Rezoning Transportation Analysis

Petition Number: 2025-117

Date	Description
11-25-25	First Review (KC)

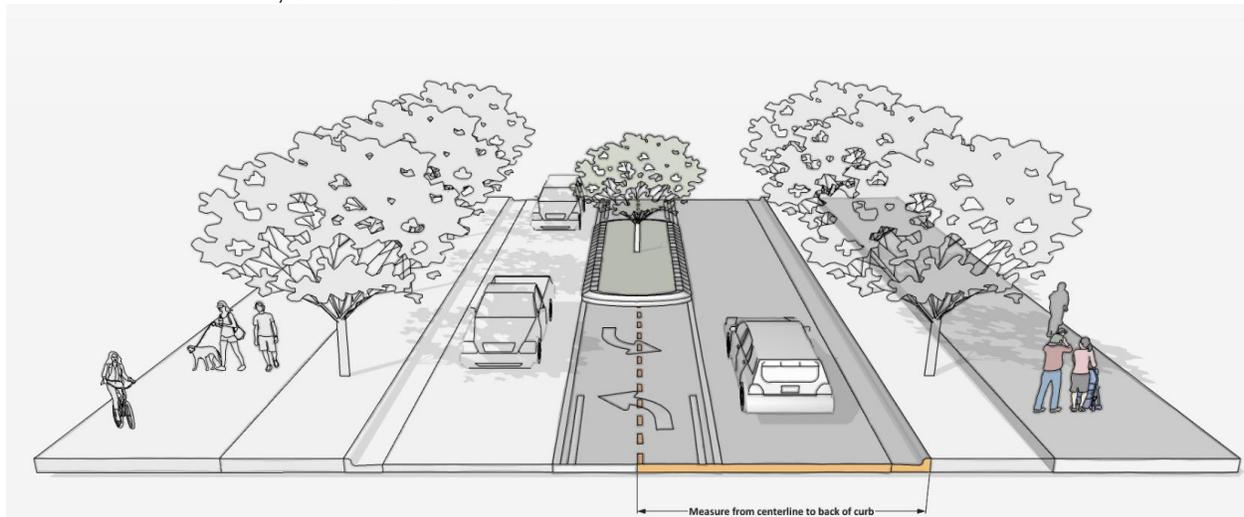
1. Curblines:

- a. **Rozelles Ferry Road:** Location of future curb and gutter is to be located 19' from centerline. Curb and gutter is not required to be constructed in coordination with NCDOT.

Label and dimension the curb and gutter from the centerline for each road on the site plan. Revise site plan and conditional note(s) to commit to labeling future curb and gutter along Rozelles Ferry Road only for reference. Infrastructure is to be placed according to the future back of curb location.

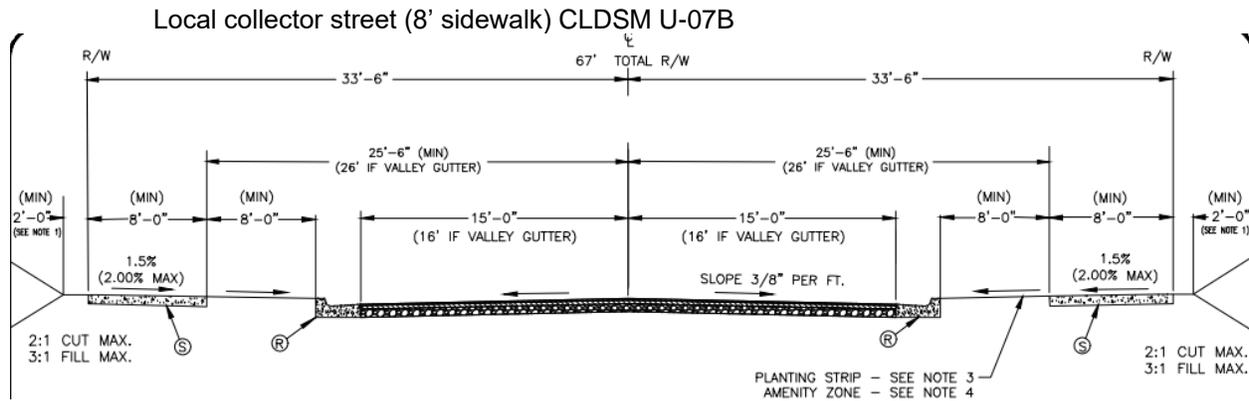
- b. **Hart Road:** Location of future curb and gutter is to be located 17.5' from centerline.

Label and dimension the curb and gutter from the centerline for each road on the site plan.

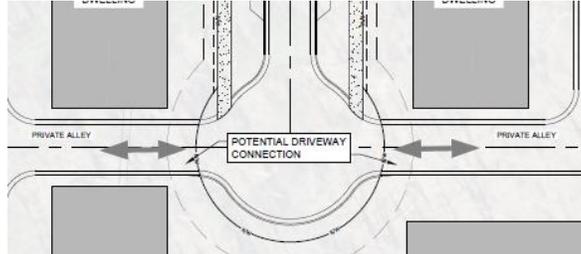
The petition's zoning falls within the low development which based on the 940 daily trips will trigger Tier 1 (3 mitigation points) for multimodal assessment. The petitioner shall review and assess the publicly accessible pedestrian network within ¼ mile walking distance of the site to identify multimodal infrastructure to meet the Tier 1 (3 mitigation points) for multimodal assessment.

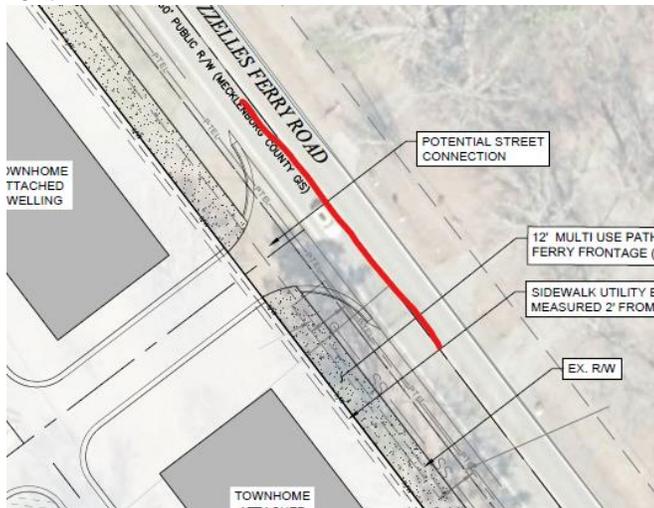
6. Revise site plan and conditional note(s) to commit to constructing the private alleys as driveway connections to a hammerhead instead of this cul-de-sac intersection design.
